CITY OF RIVERSIDE, CALIF. DEPARTMENT OF PUBLIC WORKS

STREET PLAN & F.  
MT. VERNON AVENUE

R-845

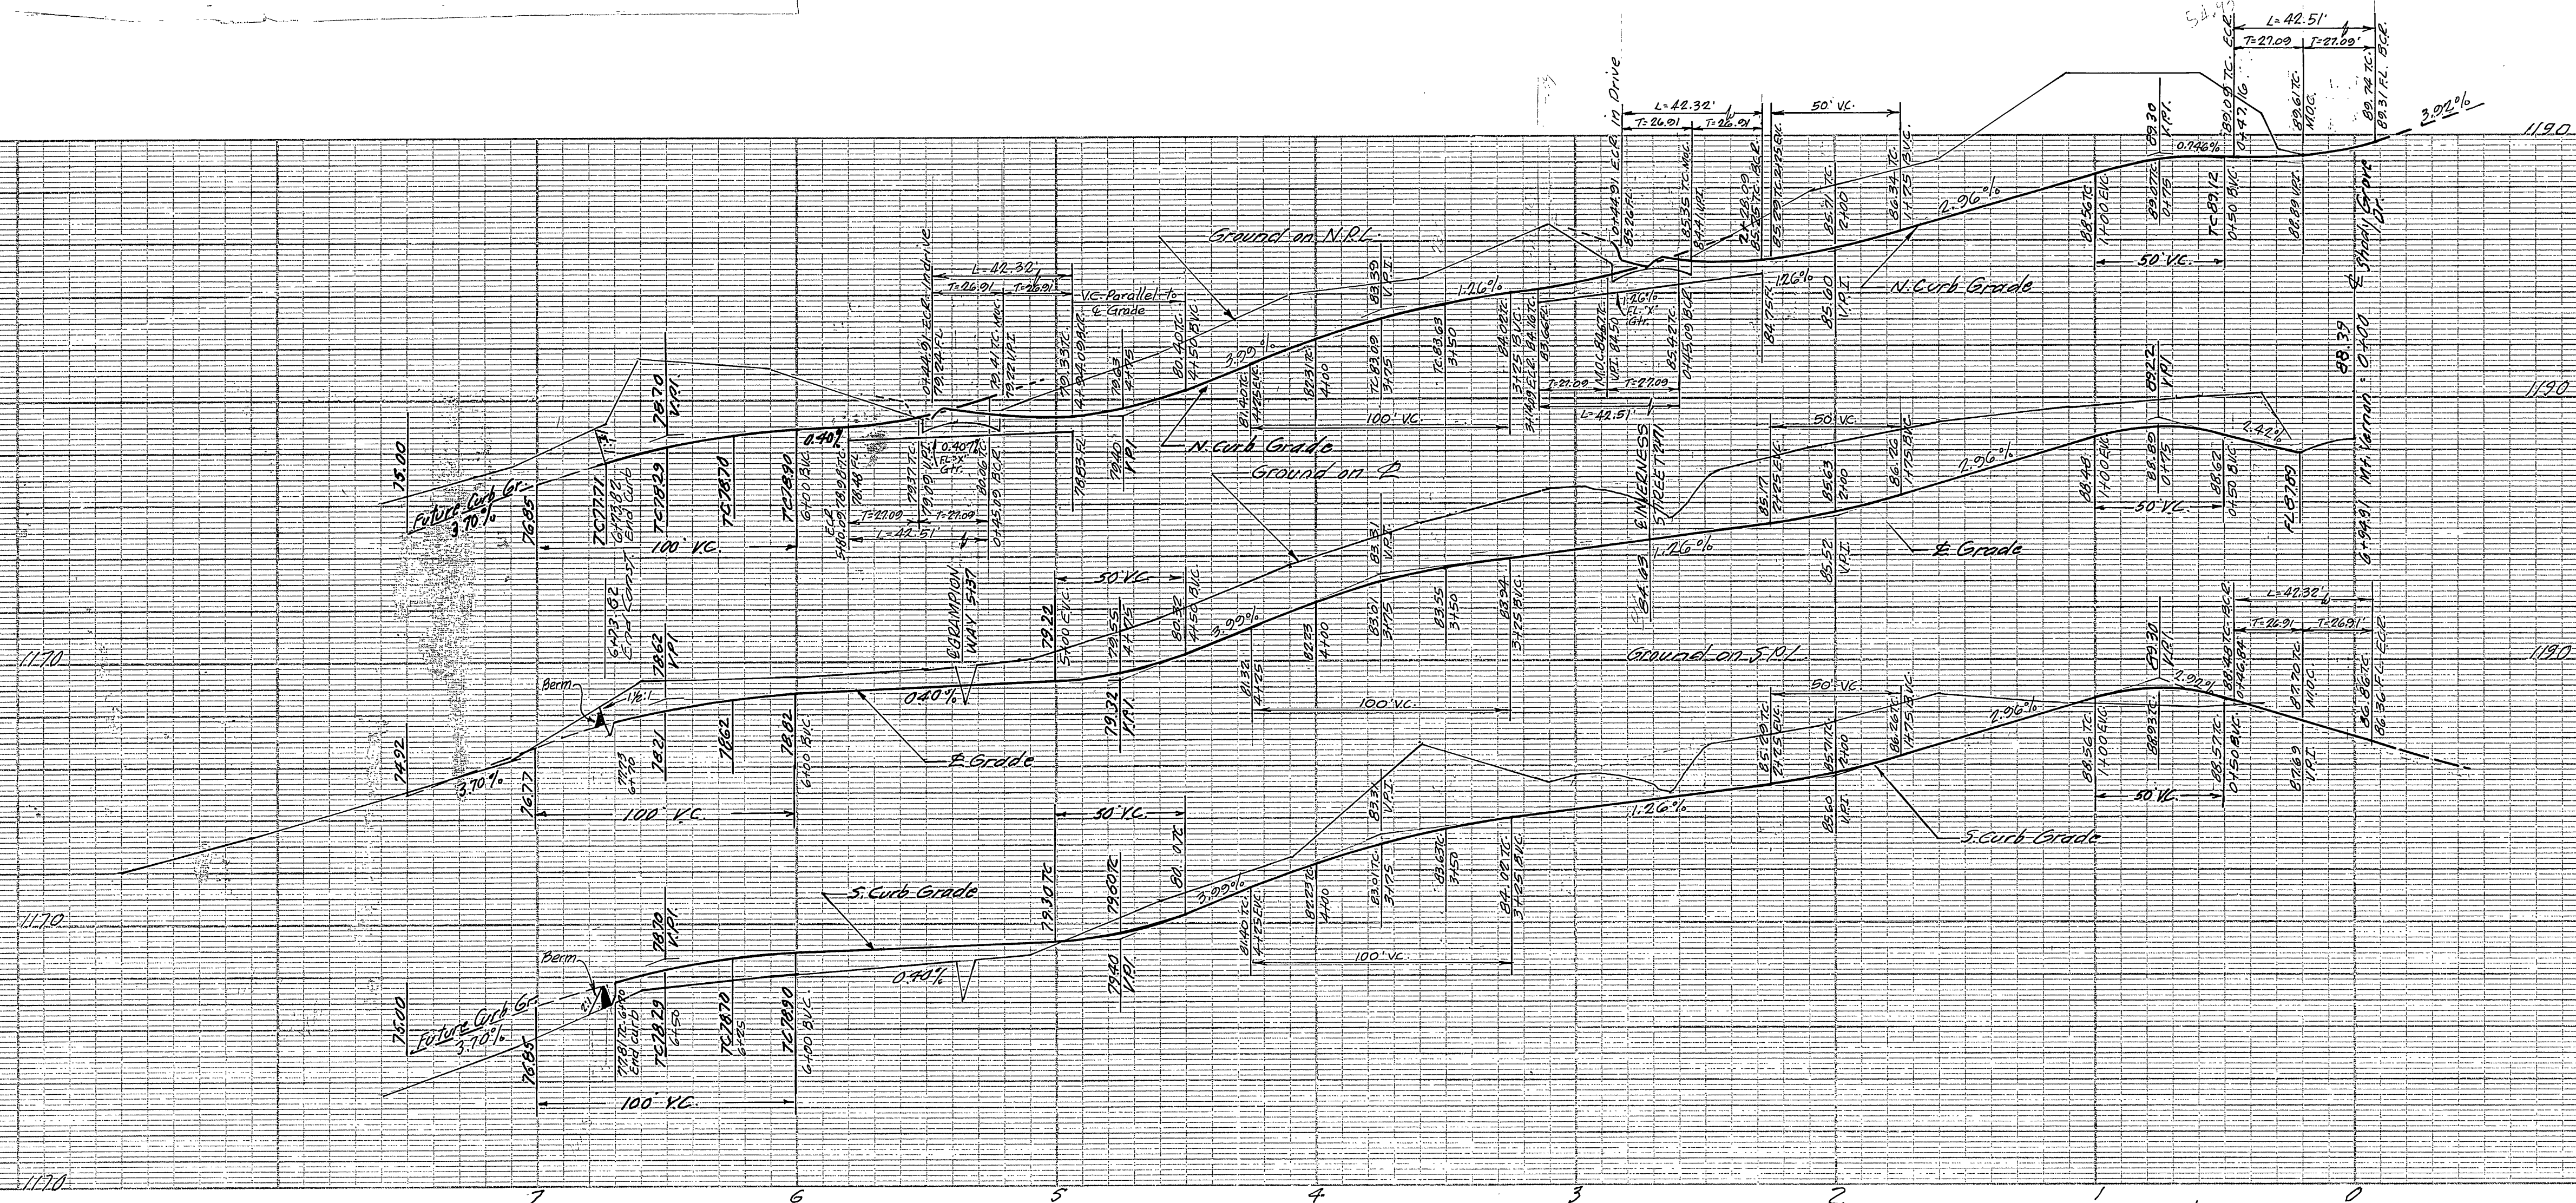
Not Built  
See R-1594

STREET  
SHADY GROVE DRIVE  
RECORD OF SURVEY N° 776  
1"=40' 1"=4'

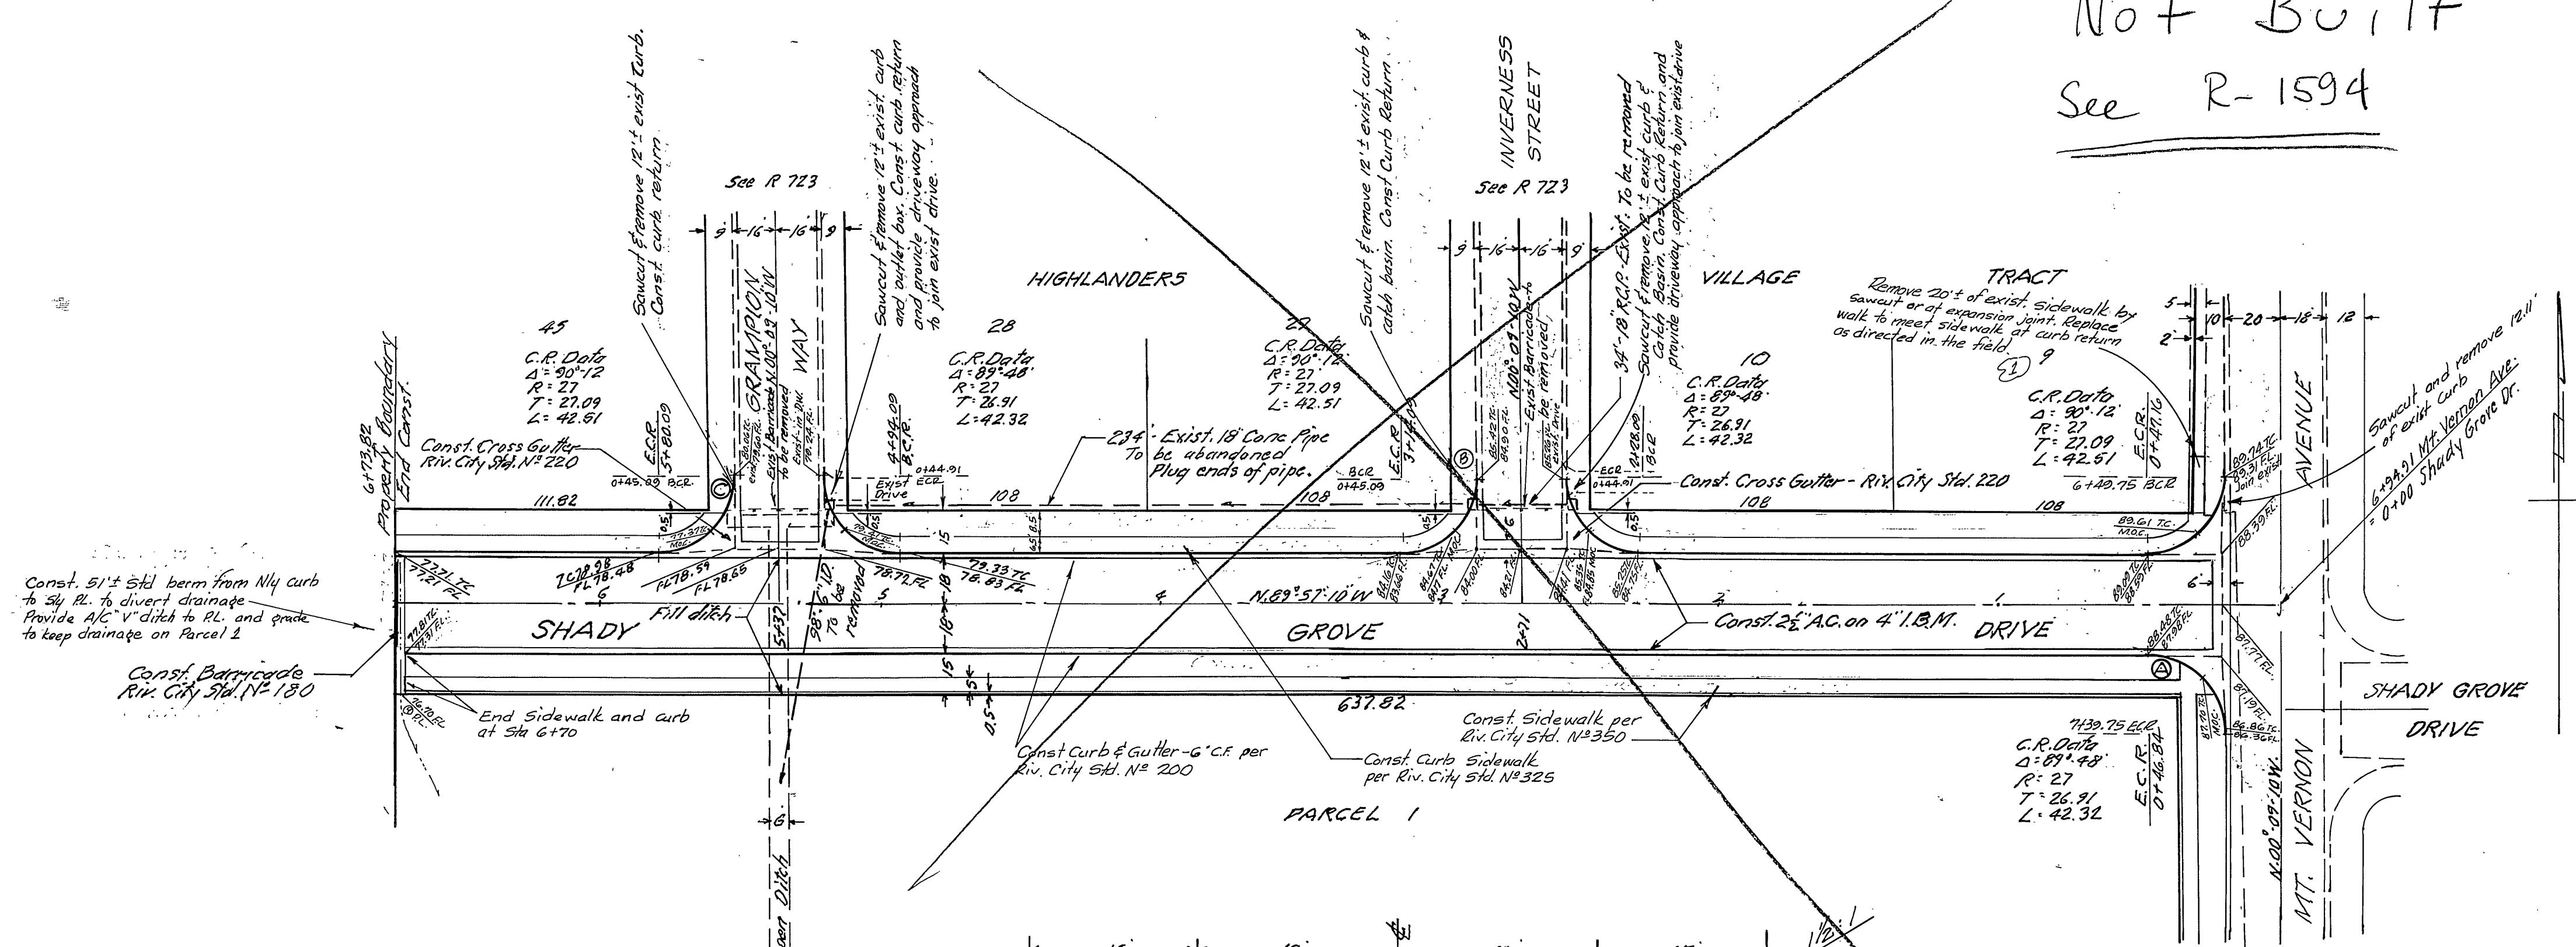
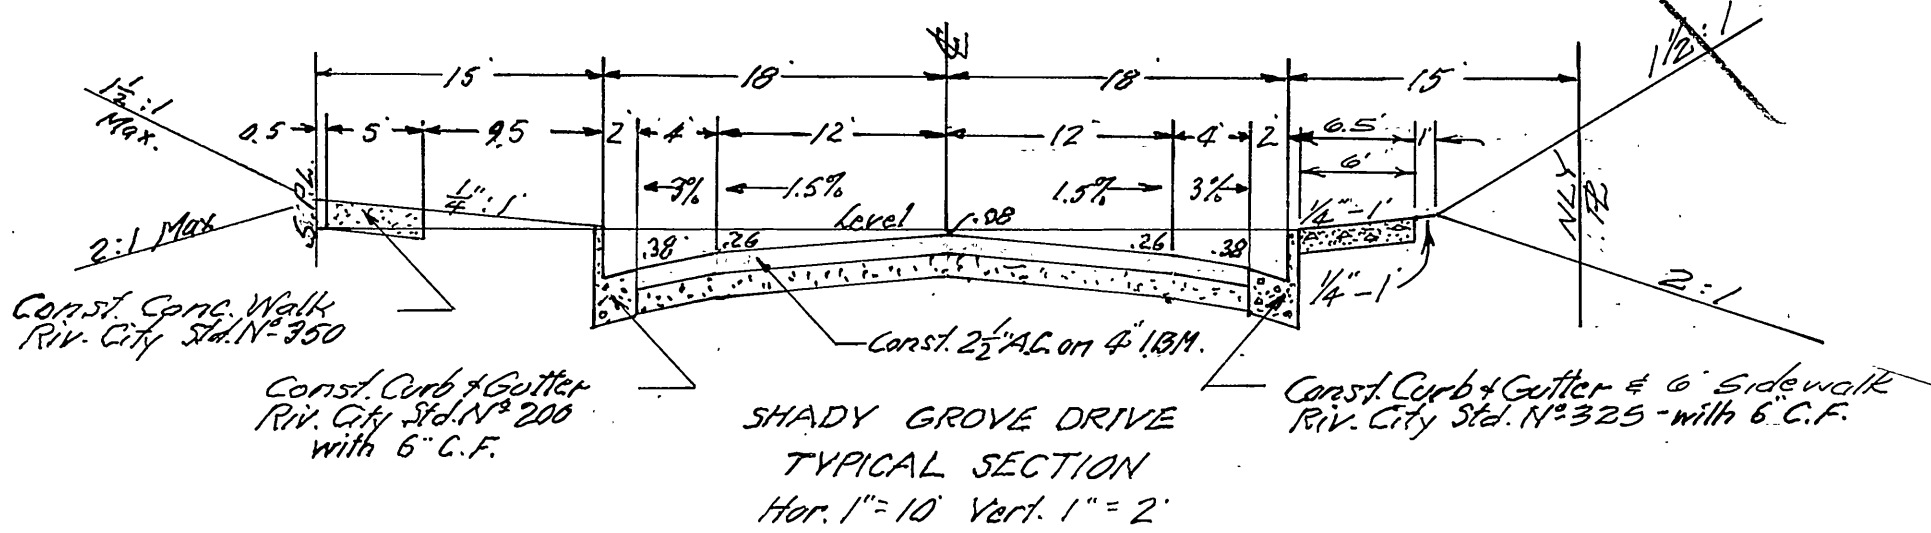
Do Not Use Plans  
City to Revise Plan  
Improvements on  
When Needed!  
Tract 5769  
9-29-68 Row

10-25-65 Sidewalk revision Nly of Shady Grove Drive Approved [Signature]
